DRAINAGE SUMMARY

PROJECT: MAUNALOA HIGHWAY, REPLACEMENT OF CULVERTS BETWEEN
MAUNALOA VILLAGE AND KAUNAKAKAI - PHASE II
PROJECT NO. RS-0460(3)

STATE OF HAWAII
DEPARTMENT OF TRANSPORTATION
HIGHWAYS DIVISION

Replacement of Culverts bet. Maunaloa
Village and Kaunakakai - Phase II

DETAILS OF 60" CULVERT AT STA. 41+42

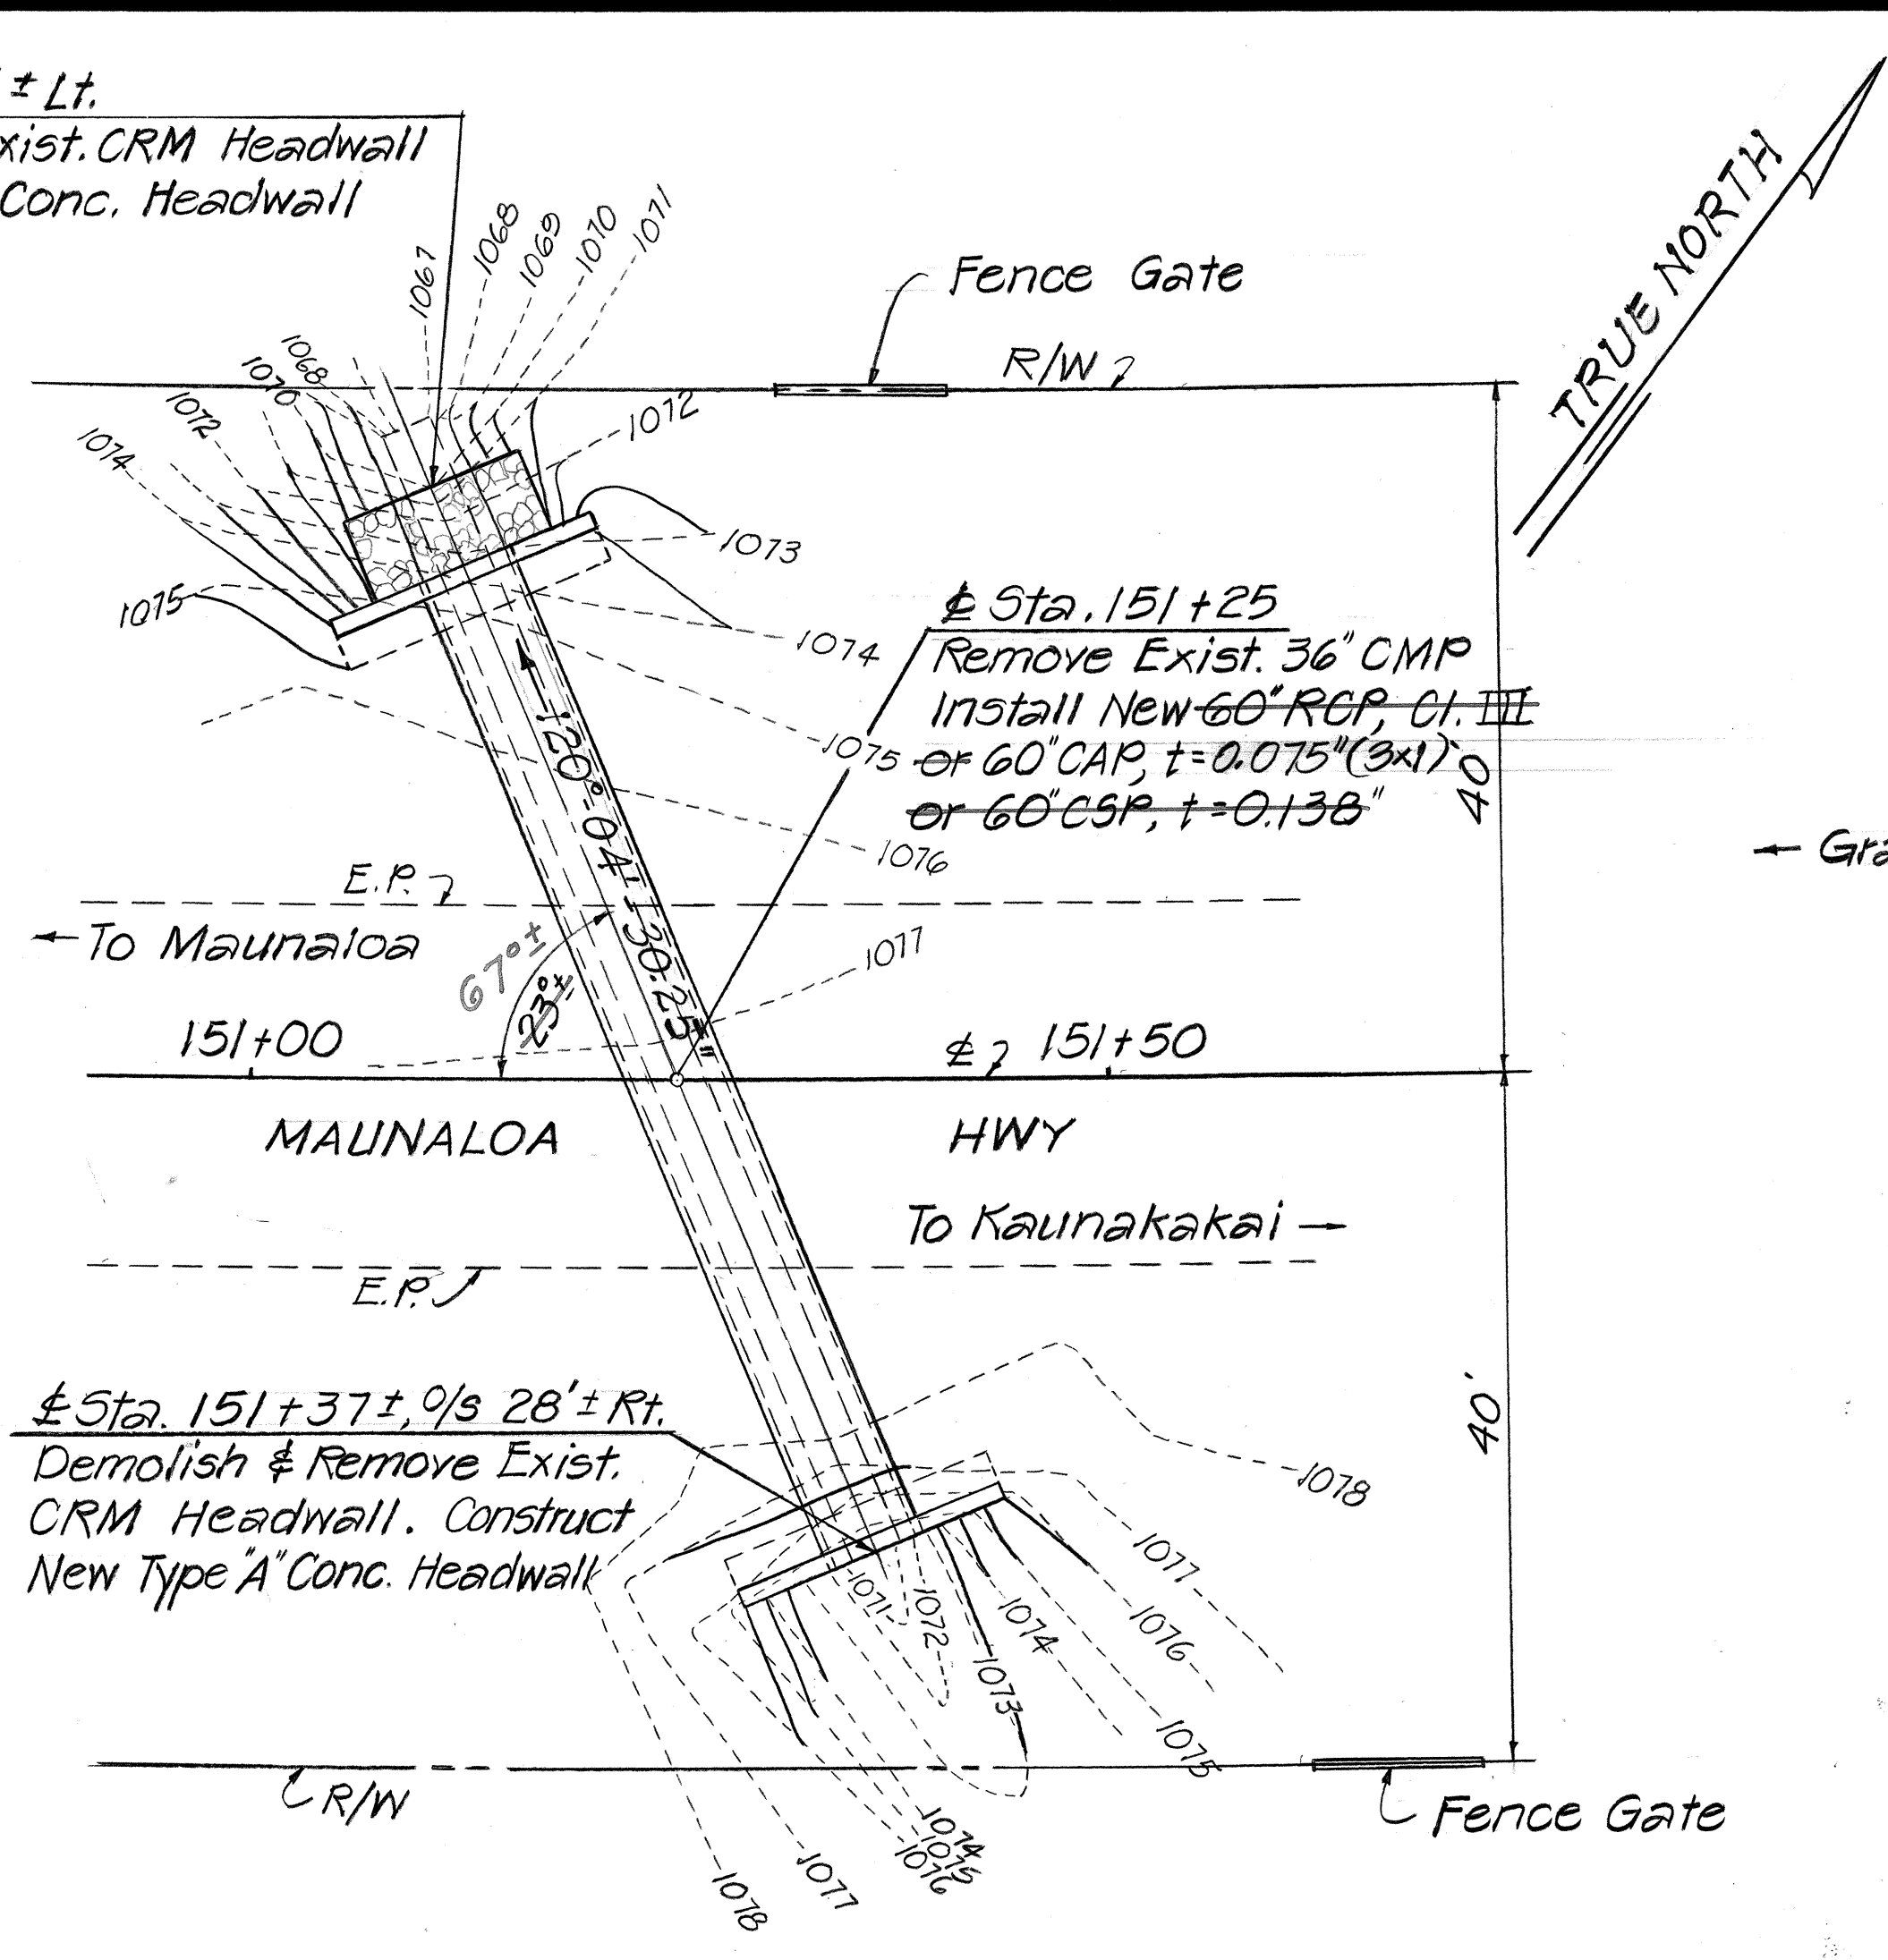
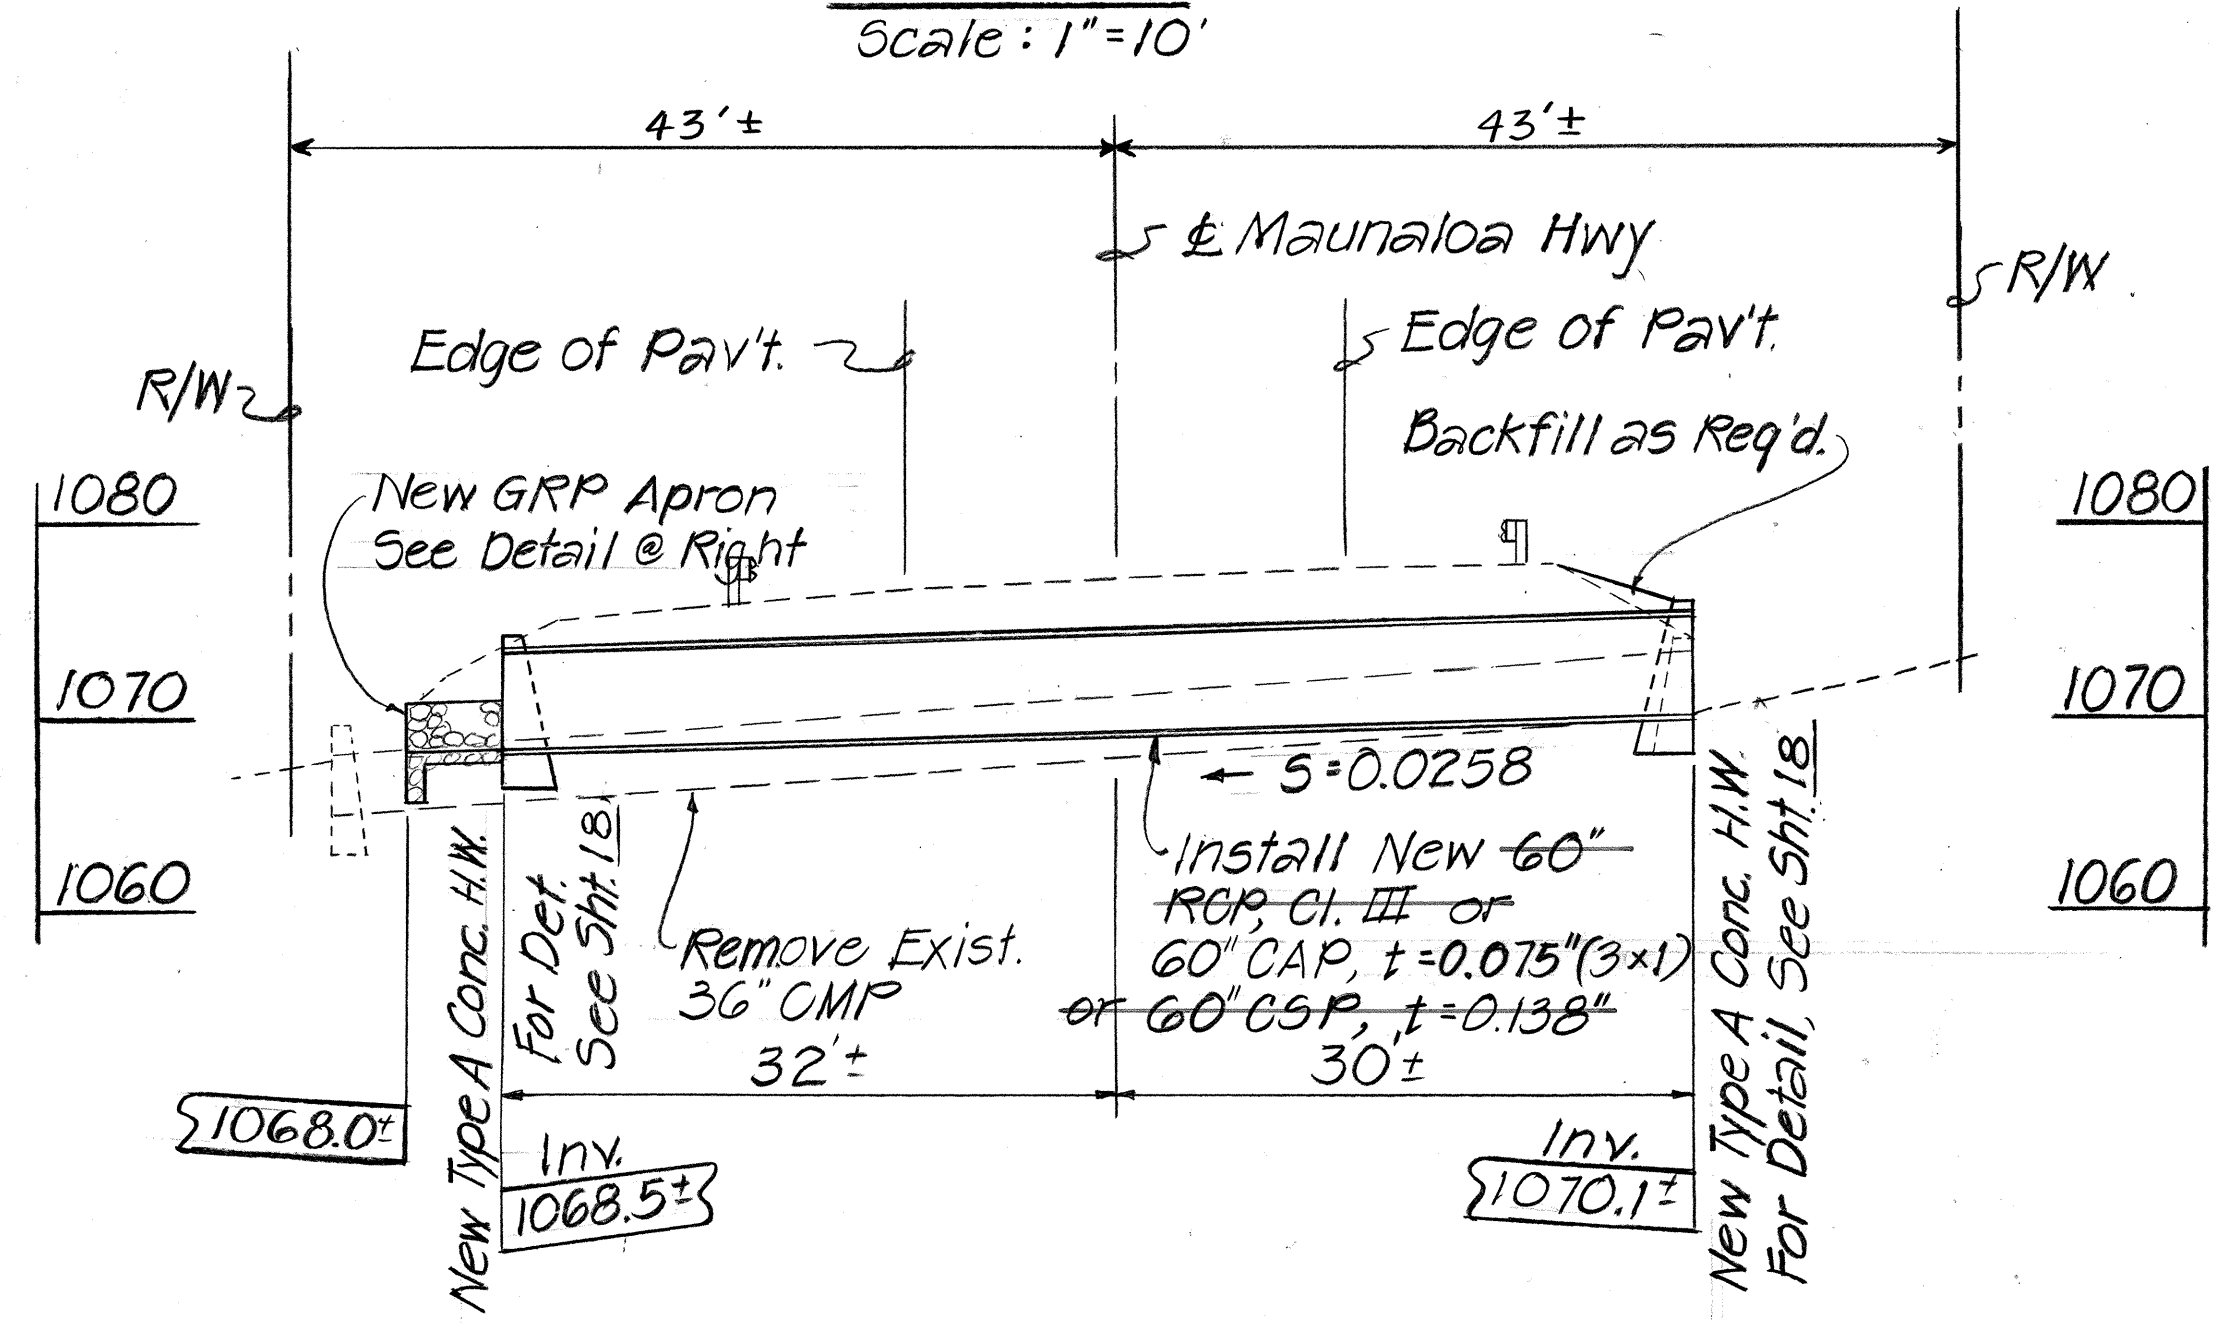
DATE	REVISION
10/23/84	Per Addendum No. 1 Changed 60" CAP t=0.135" to 60" CAP t=0.075" (3x1) and 60" CAP t=0.164" to 60" CAP t=0.075" (3x1)
